SERVICE LETTER #35

SUBJECT: Rotax 582 Choke Control

APPLICABILITY: All Rotax 582 Powered Kitfoxes

Service Letter #35
Figure 1
Choke Control Modification Details

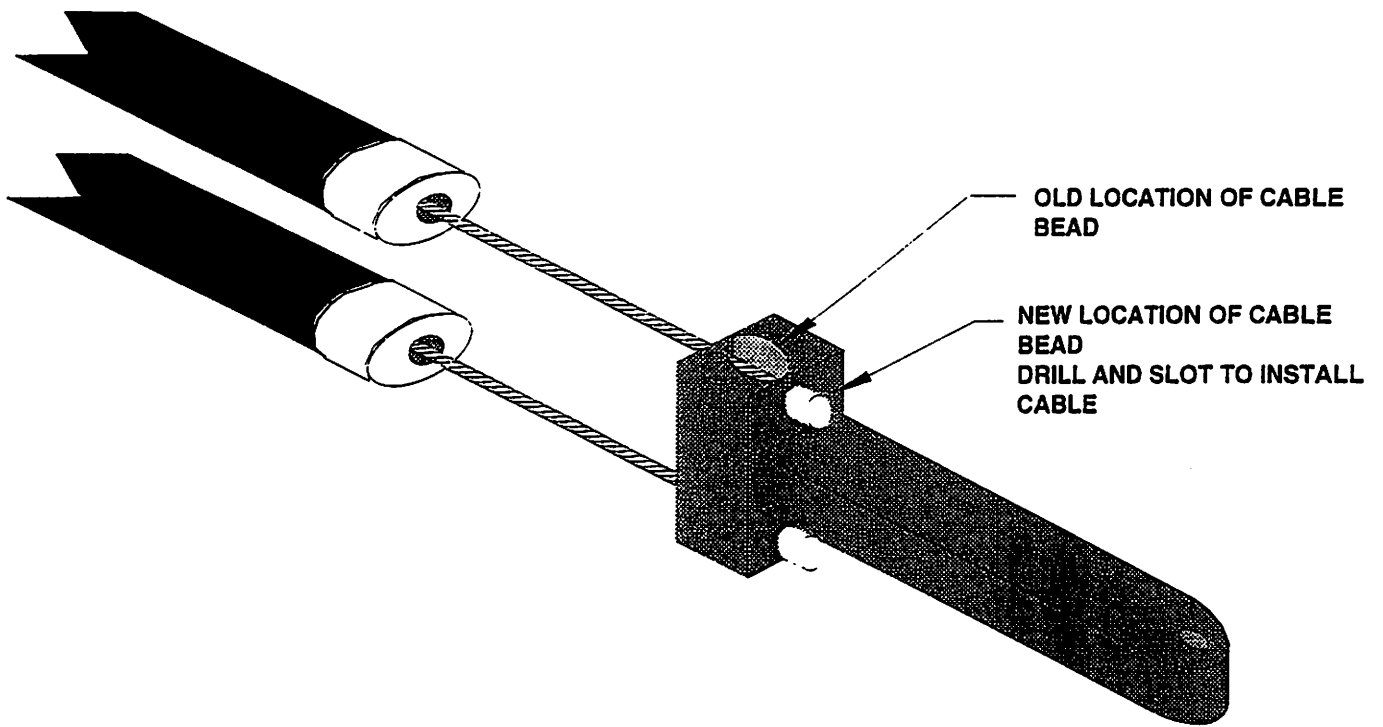
Some builders have reported two minor problems with the choke control system used on the 582. The first problem is that the choke cables are long enough that the knurled adjustment at the carburetors is all the way out. The second problem is that the cable bead at the actuator end can pull through the plastic arm, effectively disabling the carb's choke.

One modification addresses both problems. Remove the black plastic choke actuator from the instrument panel, and disassemble the actuator by removing the roll pin and pulling off the back cover to access the cable bead and motion arm. Remove the cables, and drill a 1/16" hole through the most aft wall of the bead retaining box, and then carefully slot down to the hole. Reassemble the control with the bead aft of the aft wall, and leave out the spring. The drawing included with this letter will help you identify the parts. This modification makes the bead more secure in the action arm, and effectively shortens the cables. Readjust the chokes at the carburetors after re-installing the choke control on the aircraft.
